Addendum 3

Client: Creswell School District
Project: CHS Academic Building Improvements (Primary) Project
Date: March 11, 2026
To: Interested Bidder
Prepared by: Curt Wilson, AIA; Principal, Wilson Architecture

This Addendum modifies the Project Manual, Specifications, and Drawings as follows:

1 NORTH/SOUTH SECTION - VESTIBULE
A5.00 1/4" = 1'-0"

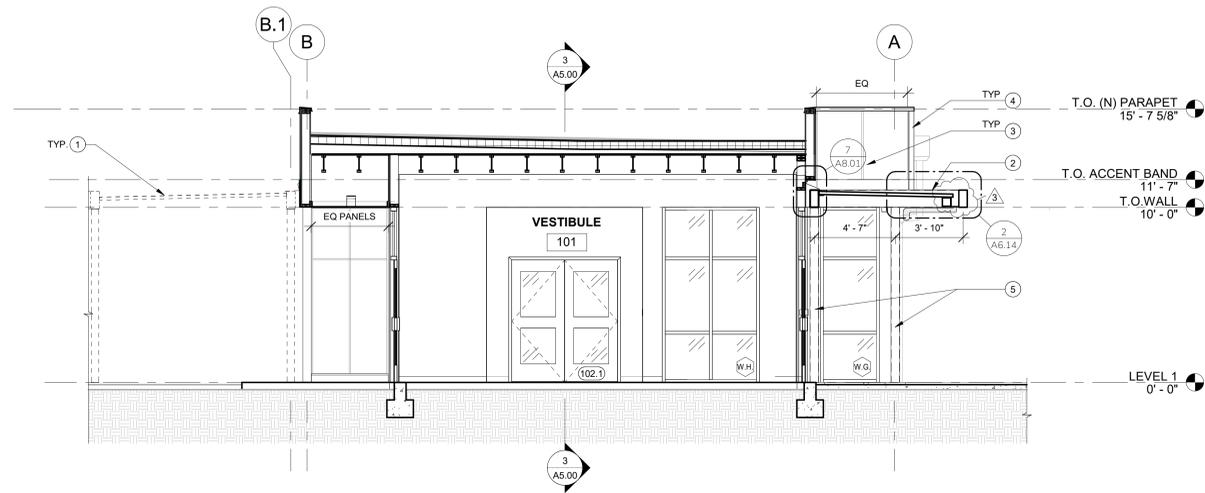
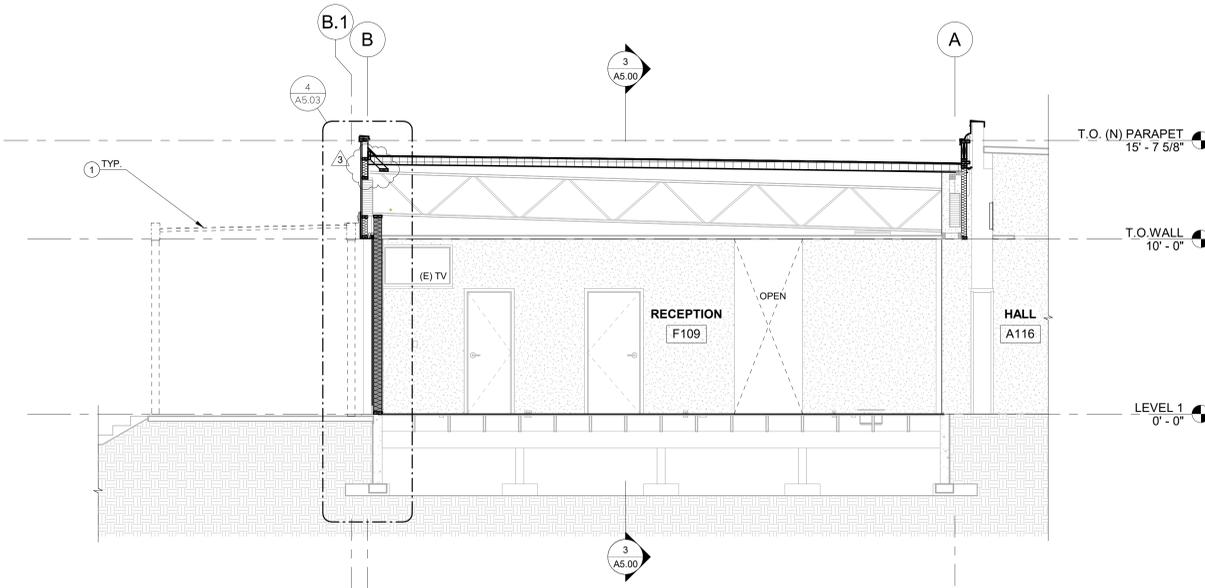
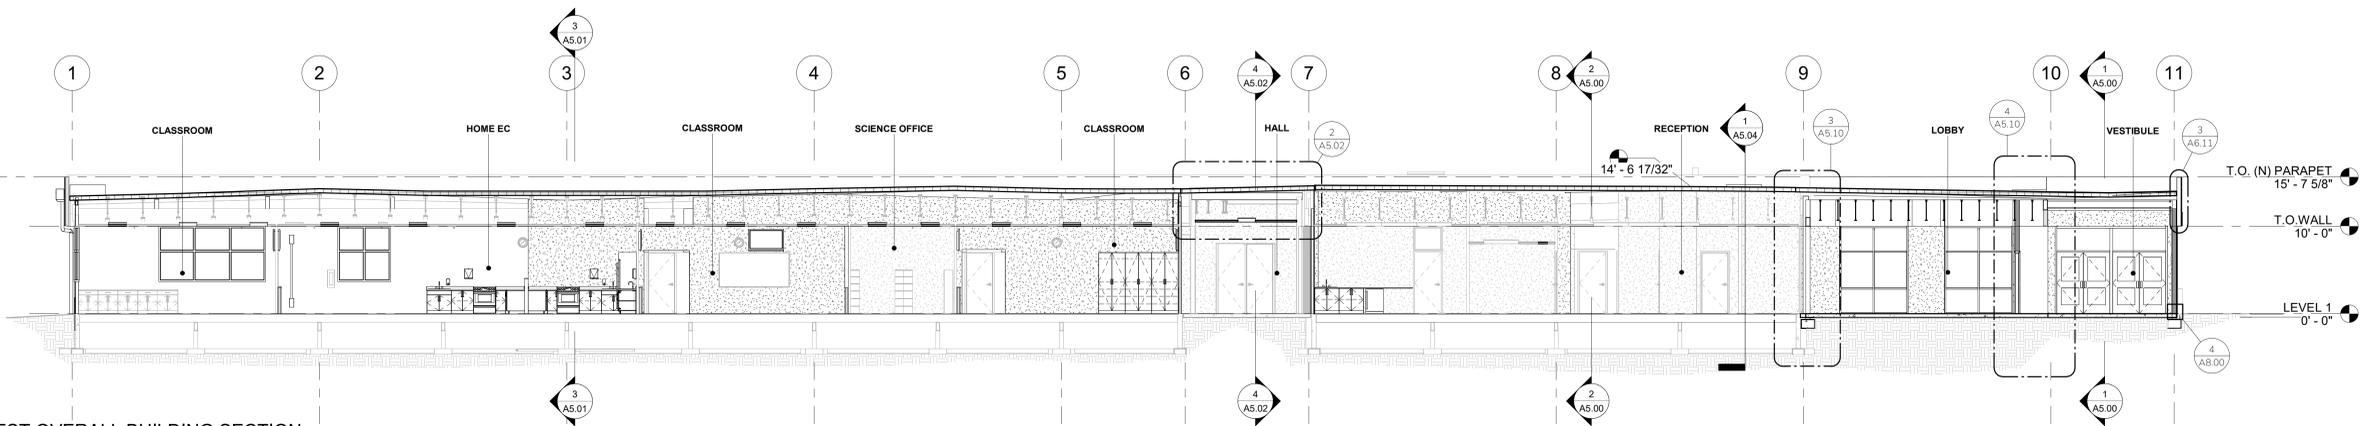
- 3.9. Sheet A5.00 – Building Sections

- a. Replace original sheet with attached version. A brief summary of the changes include:
 - Parapet bracing added to the section.
 - Edge of Entry Awning revised.

1 DEMO WALL SECTION - GL-6
A5.03 3/4" = 1'-0"

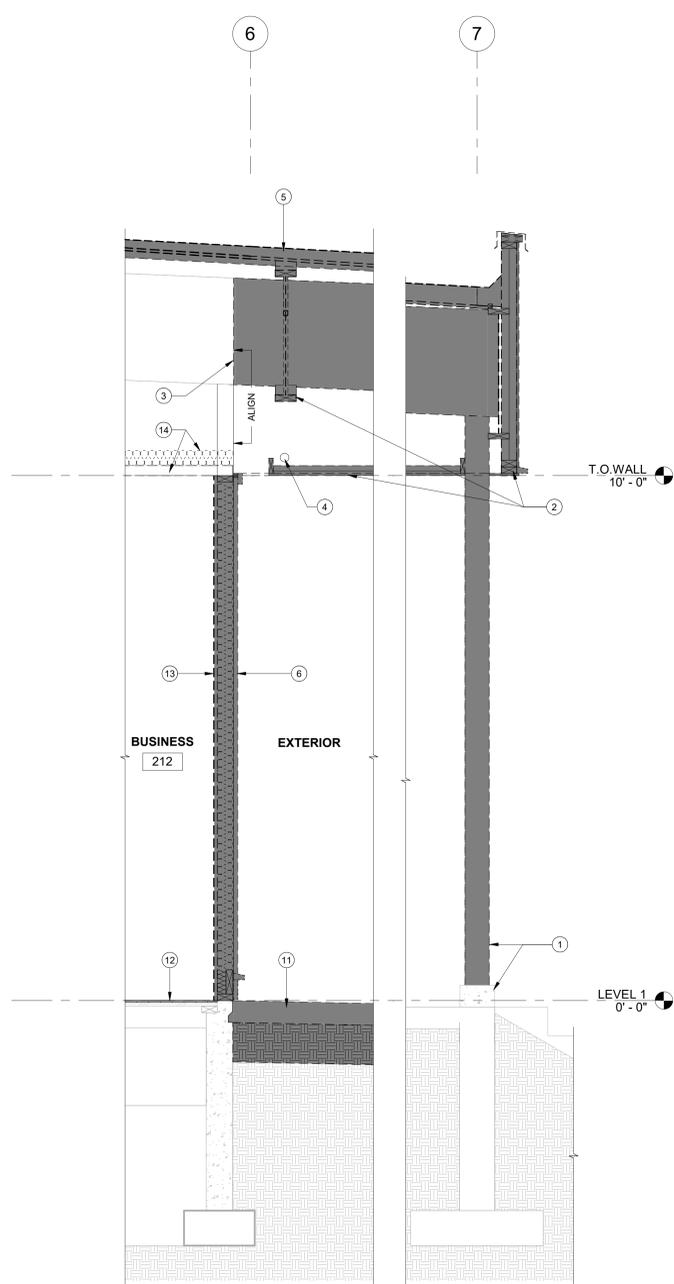
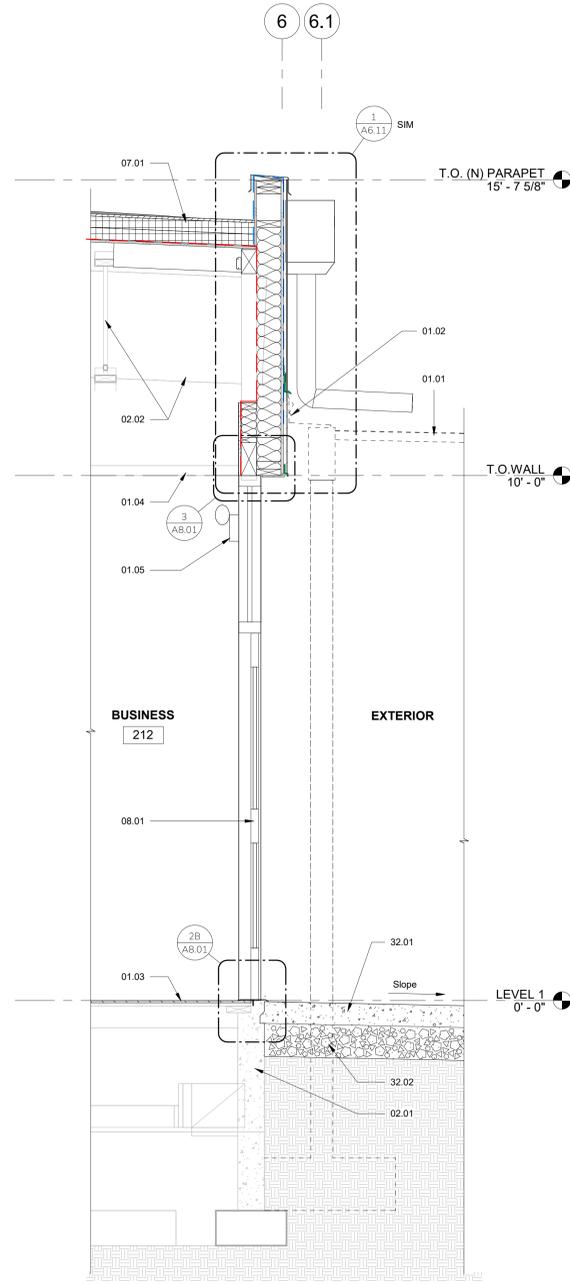
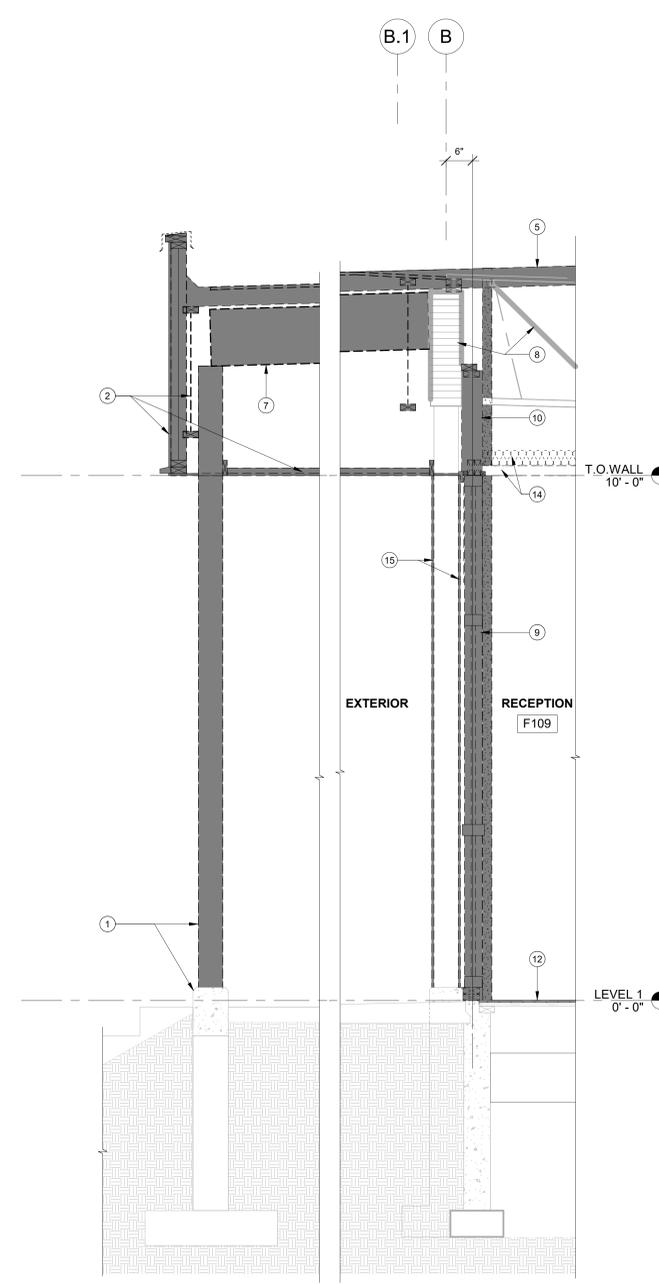
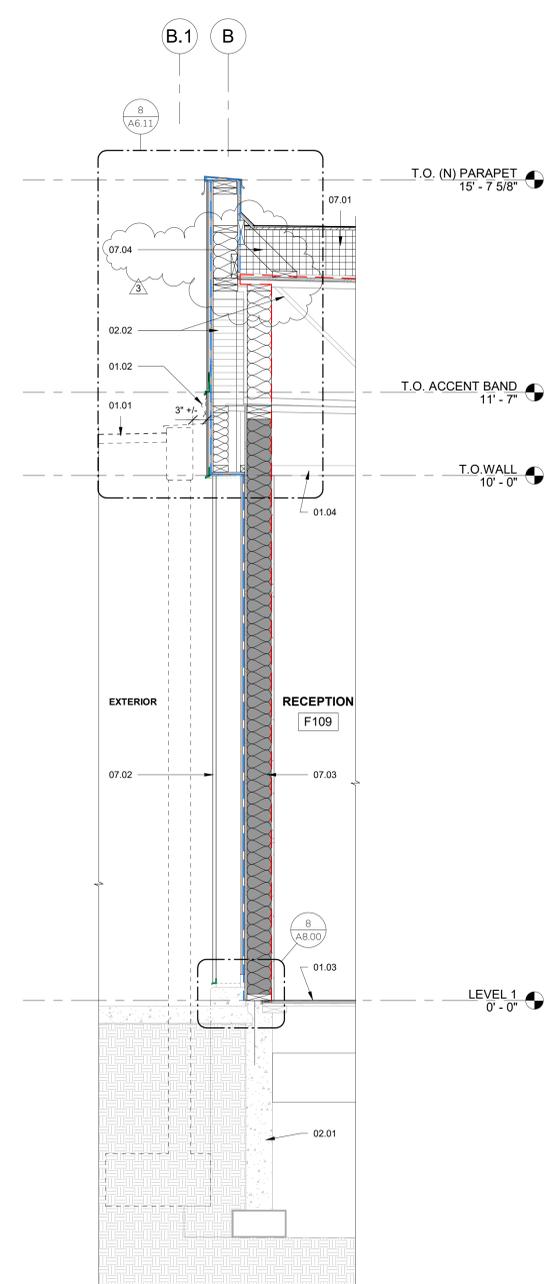
- 3.10. Sheet A5.03 – Demo and New Wall Sections
- a. Replace original sheet with attached version. A brief summary of the changes include:
 - Parapet bracing added to the section.

2 WALL SECTION - GL A
A5.04 3/4" = 1'-0"

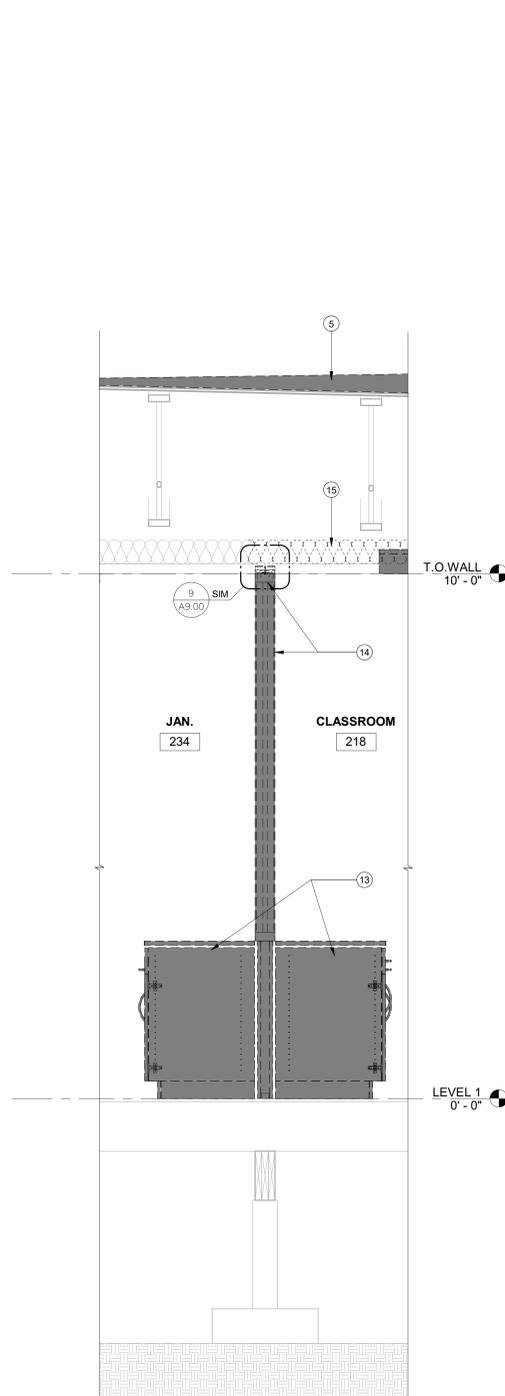
- 3.11. Sheet A5.04 - Demo and New Wall Sections
- a. Replace original sheet with attached version. A summary of the changes include:
 - Note about stucco repair added to detail 2.

1 GL 6 PARAPET
A6.11 1 1/2" = 1'-0"

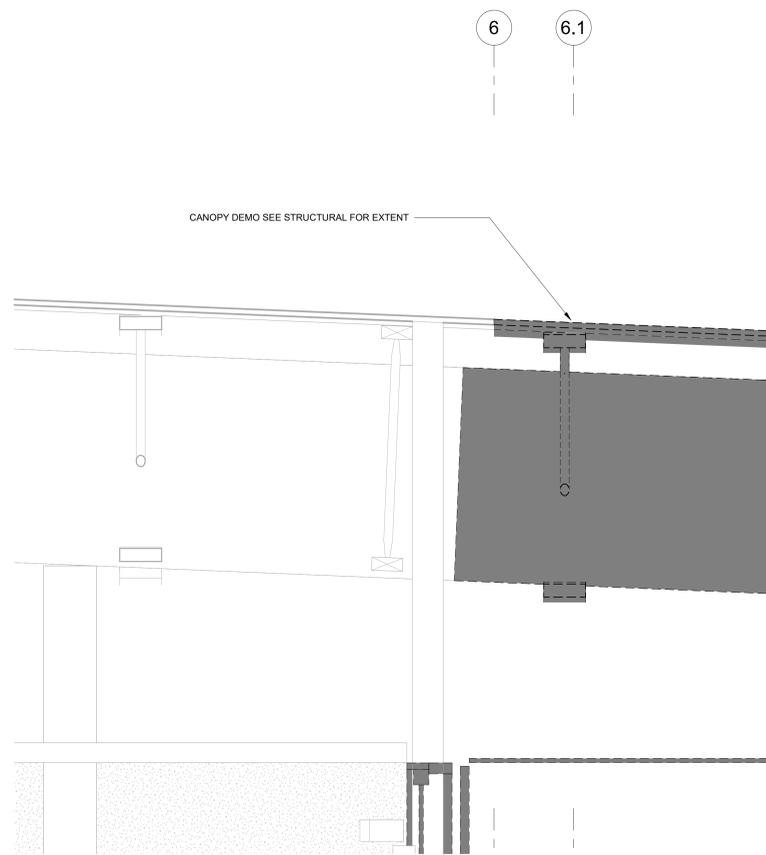
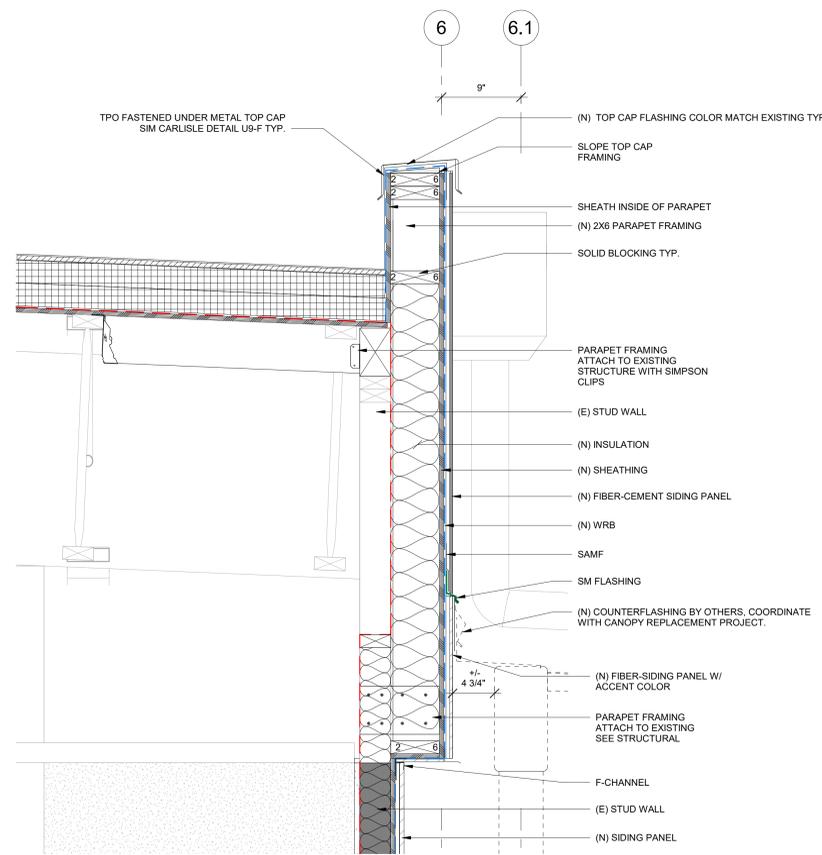
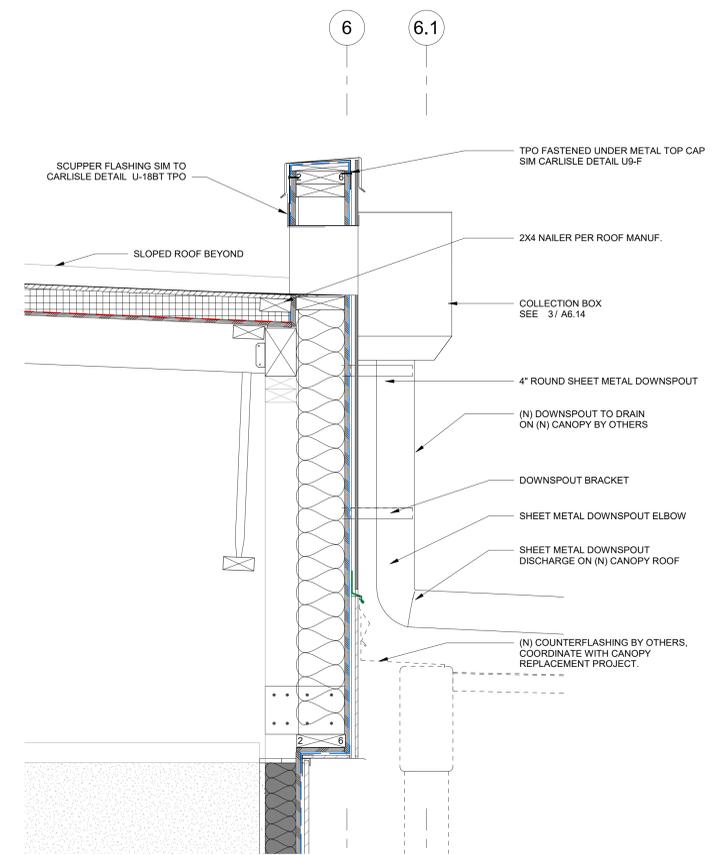
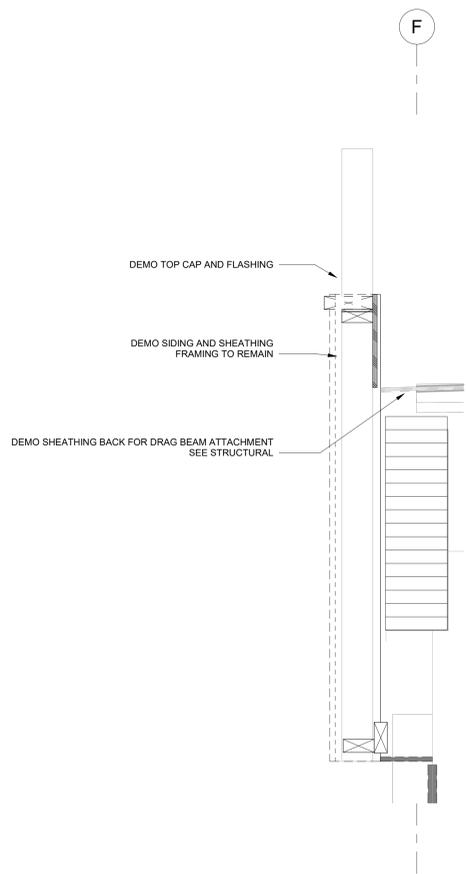
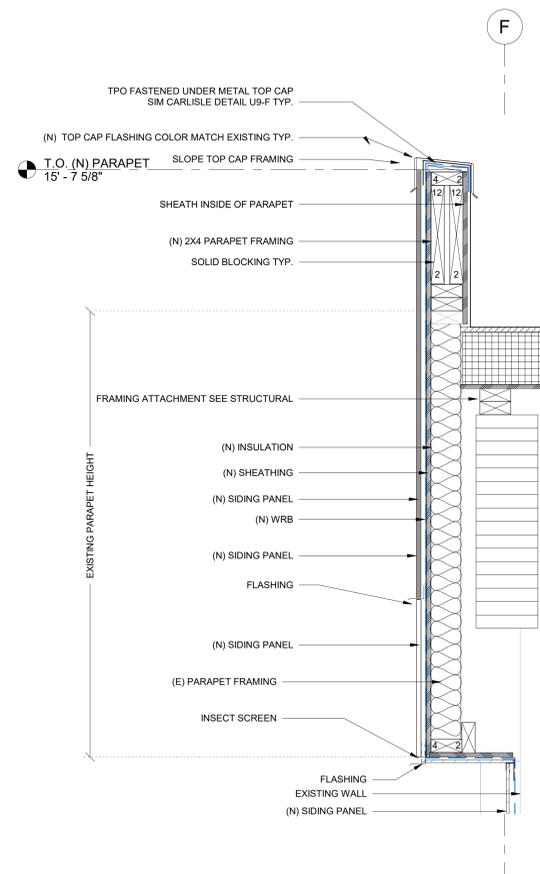
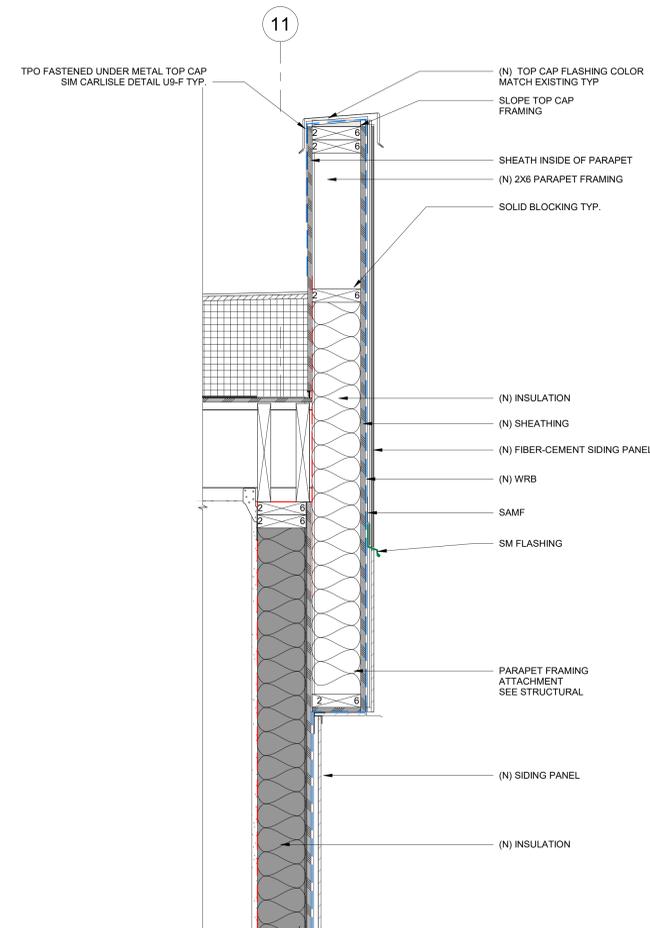
- 3.12. Sheet A6.11 – Parapet Details
- a. Replace original sheet with attached version. A brief summary of the changes include:
 - Parapet bracing added to the detail.

1 ENTRY AWNING @ GL 10
A6.14/ 3" = 1'-0"

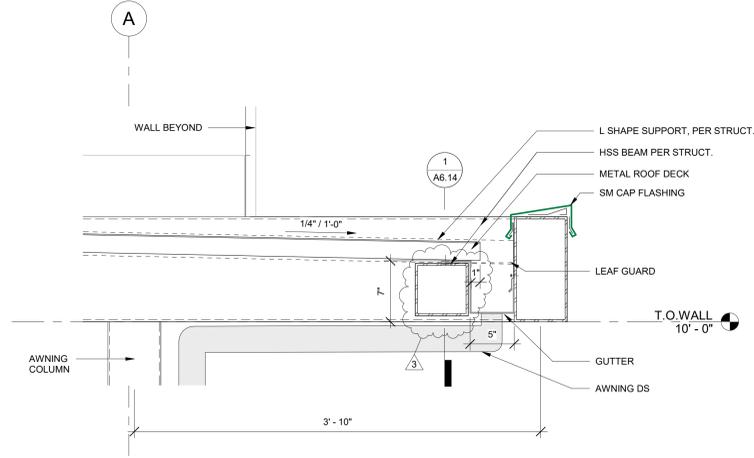
- 3.13. Sheet A6.14 – Roof Details
- a. Replace original sheet with attached version. A brief summary of the changes include:
 - Edge of Entry Awning revised.

7 WINDOW HEAD @ VESTIBULE
A8.01 3" = 1'-0"

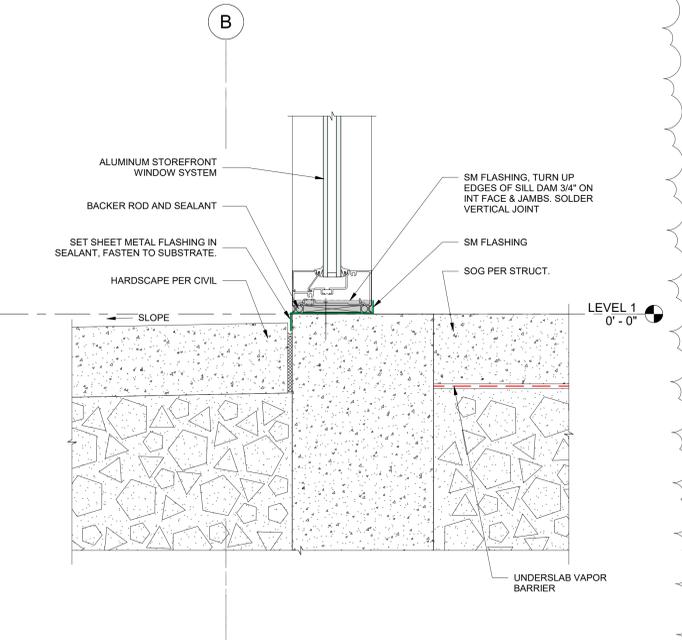
- 3.14. Sheet A8.01 – Window/Door Details
- a. Replace original sheet with attached version. A brief summary of the changes include:
 - Window Head at Vestibule detail revised.
